SERVICE BULLETIN

VENT AIR SCOOP INSTALLATION

All McDonnell Douglas Helicopter Systems (MDHS) MD900 helicopters, serial number 900-0002 thru 900-0050.

Figure 1. Vent Air Scoop Installation

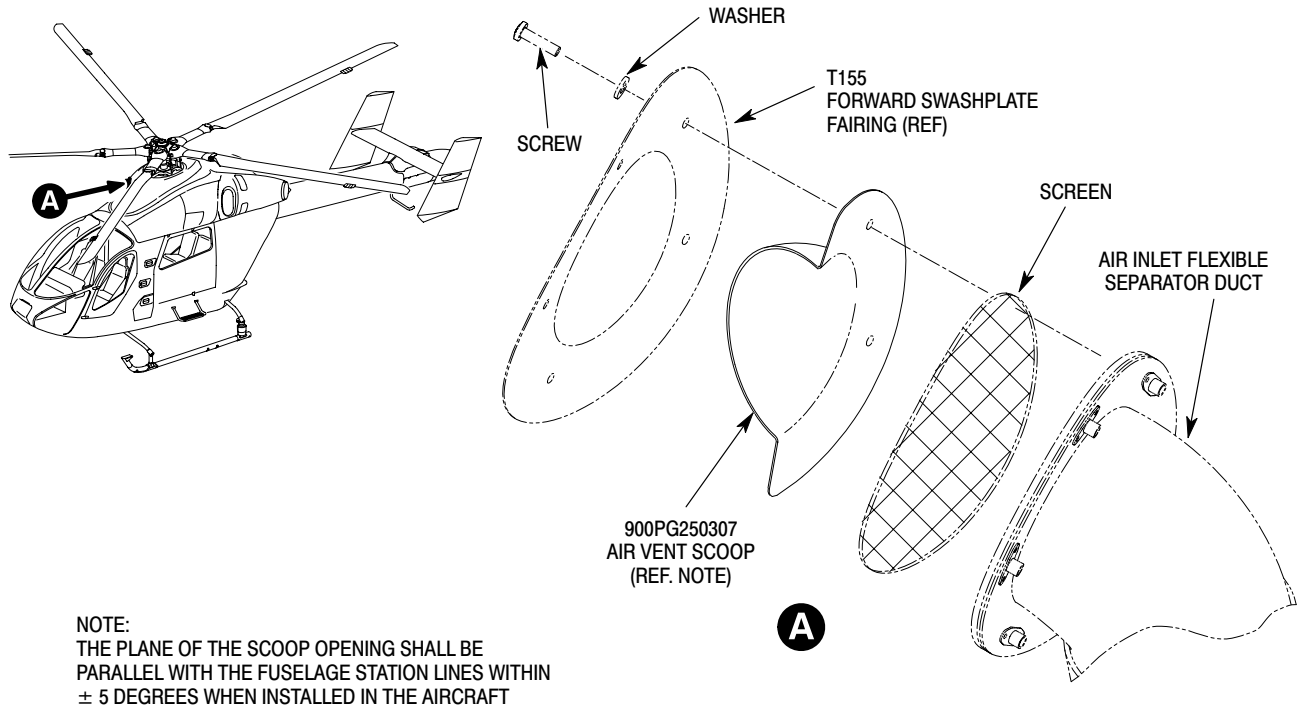
Improve environmental conditions by increasing the flow of fresh air inside the cabin and crew compartment of the helicopter.

- (1). Remove forward access door assembly R155 (Ref. Section 53-30-00).
- (2). Remove screw(s) and washer(s) from swashplate fairing T155 and remove air inlet flexible separator duct. Retain screws and washer for reinstallation.
- (3). Match scoop to drilled holes located in forward swashplate fairing. The scoop shall be parallel with the fuselage as shown in figure 1. Drill **0.195-0.206 in. dia. (4.95-5.18 mm)** holes (#6 drill size).
- (4). Paint scoop to match aircraft color.
- (5). Install air vent scoop, screen and flexible separator duct with previously removed screws and washers.
- (6). Install forward access door assemblies R155 (Ref. Section 53-30-00).
- (7). Inspect aircraft for FOD debris before releasing for flight.
